RESPONSIVENESS SUMMARY

**SPOKANE RIVER UPRIVER DAM PCB SITE
REMEDIAL INVESTIGATION/FEASIBILITY STUDY
&
DRAFT CLEANUP ACTION PLAN**

Spokane River Upriver Dam PCB Site

Response to Comments on Site RI/FS and draft Cleanup Action Plan

Figure 27
Depth Profiles of PCB Concentrations in Sediments Above Upriver Dam
Upriver Dam Spokane, WA

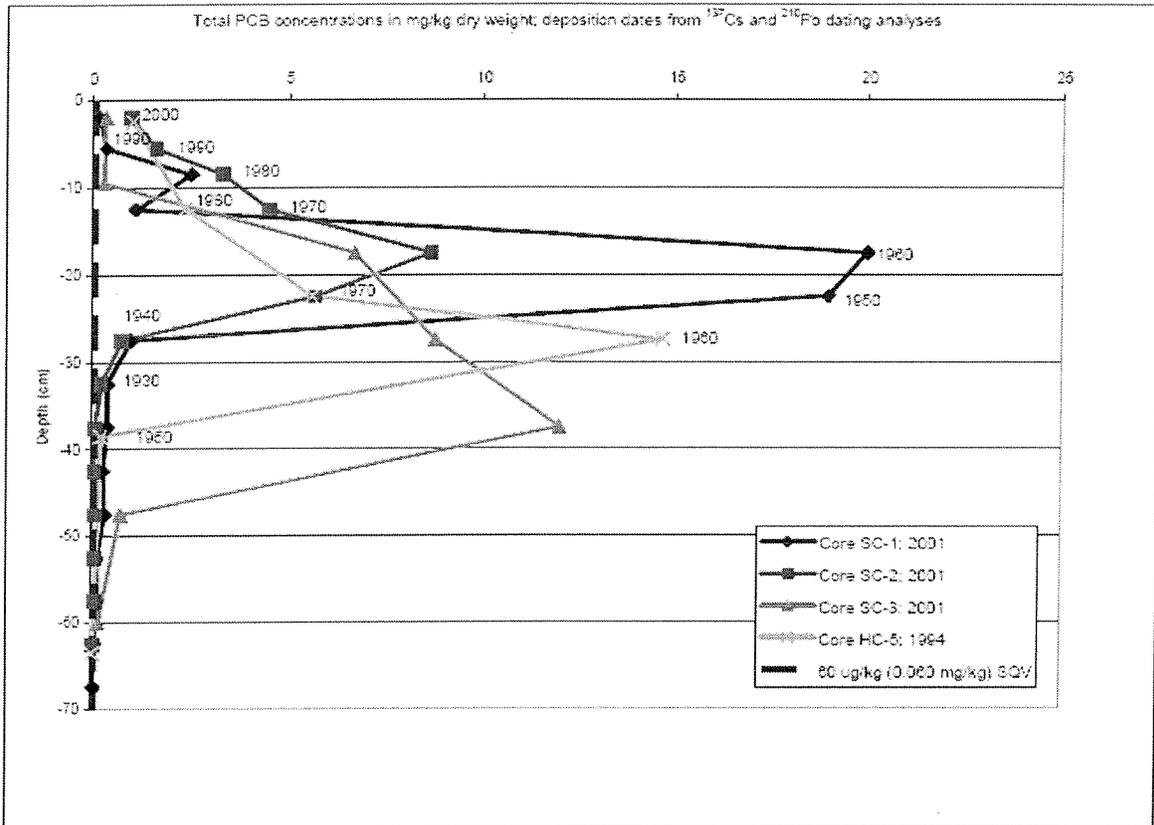
Figure 27 (reproduced below) indicates that PCB concentrations are much lower within 10 cm of the sediment surface than below approximately 15 cm. An attempt was made in the RI to date the sediment levels, which is shown on the figure. Sediment accumulation rates have been 0.4 to 1.0 cm/year. It appears that the high PCB concentrations in the sediment preceded 1980. PCBs were banned in 1978, and the discussion indicates that decrease in PCB in sediment profiles analogous to that shown on the figure are common at various locations in the US.

Since IEP did not initiate processing of Old Newspapers, potentially the source of PCBs in the IEP wastewater, until 1991, it appears very unlikely that IEP has contributed to any of the

accumulation of PCBs in the sediments behind Upriver Dam that have resulted in its designation of a site in need of remediation.

- Also for comparison, calculation of the total amount of PCBs in the 13,600 cubic yards of sediment deposit upstream of Upriver Dam, at a presumed average concentration of 5 mg/kg dw (see RI Figure 27 reproduced above) results in a value of about 77 kg or 170 pounds.
